Your ref: D18007866MFSH

Our ref: CS/FCI18019876/Kvd3

INITIAL INSPECTION REPORT OF VEHICLE NO. SHD 909M

ADJUSTMENT ON REPAIR COST FOR VEHICLE NO. SHD 909M

Description of Damage:

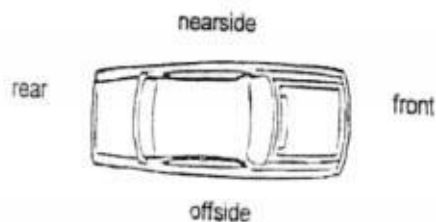
The vehicle sustained damages at the front o/s door mirror

Comments/Present Status:
Damages Consistent
